# SUBMISSION

a written submission by way of objection

RE: DA2022/0469 1102 Barrenjoey Road, Palm Beach

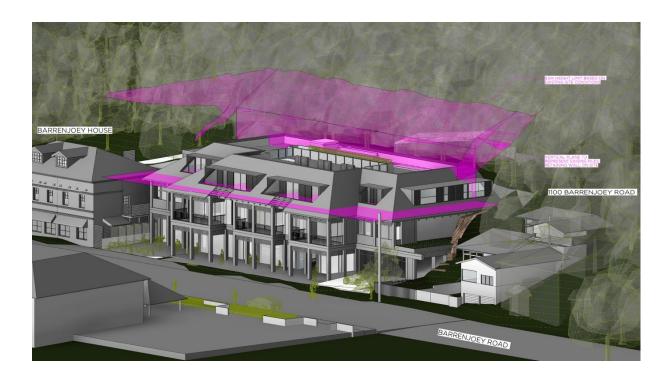
I refer to the latest set of Architectural Drawings, dated 8 March 2023 submitted as a response to that request.

The proposed development is still substantially beyond Height and Setback controls. The majority of the upper level exceeds the controls. The proposed development is significantly out of scale to Barrenjoey House. The proposed length of the building, at over 44 meters, will present a jarring outcome set against the more modest scale of Barrenjoey House.

- 1. The storey height of the proposed Ground Floor at 3.99m is excessive considering the size of the commercial units. My clients ask the Panel to reduce the storey height to 3.74mm, and to lower the First Floor to FFL 6.3m. This modest adjustment of 250mm would not affect the amenity or layout of the commercial areas.
- 2. The storey height of the proposed First Floor at 3.3m is excessive. My clients ask the Panel to reduce the storey height to 3.1m, and to lower the Second Floor to FFL 9.4m. This modest adjustment would also not affect the amenity or layout of the apartments on this level.
- 3. The parapet height of RL 13.75m is excessive and unnecessary. My clients ask the Panel to reduce the height of the Parapet to RL 12.35 which would match the ridge height of Barrenjoey House.

- 4. Locating the Mechanical Plant and HWS on the roof, which would have the potential to create visual and noise pollution to my clients, is just not necessary. My clients ask the Panel to require that it be relocated either to the area behind the lifts and stairwell on level 1 or alternatively in the basement
- 5. Although the application does not seek approval for the roof top area to be used for recreation my clients are concerned that the provision of stairs from level 2 to the rooftop provides the potential for such use. Therefore, my clients ask the Panel to require those stairs from floor level 2 to the roof be deleted so that the rooftop is not accessible to residents, visitors or the public.
- 6. The flat roof structures over the balconies on level two contribute to the excessive bulk and scale. My clients ask the Panel to require them to be removed.

- o CONDITION 1: Reduce the Level 1 Floor Level to FFL 6.3m.
- o CONDITION 2: Reduce the Level 2 Floor Level to FFL 9.4m.
- CONDITION 3: Reduce parapet height FFL 12.35m to match the ridge height of Barrenjoey House
- CONDITION 4: Remove the screening and screen planting from the roof and relocate the Mechanical Plant and HWS to the area behind the lift/stairwell on level 1 or to the basement.
- o CONDITION 5: Delete stairs from level 2 to the roof.
- o CONDITION 6: Delete the flat roof structures over all the balconies on level 2.
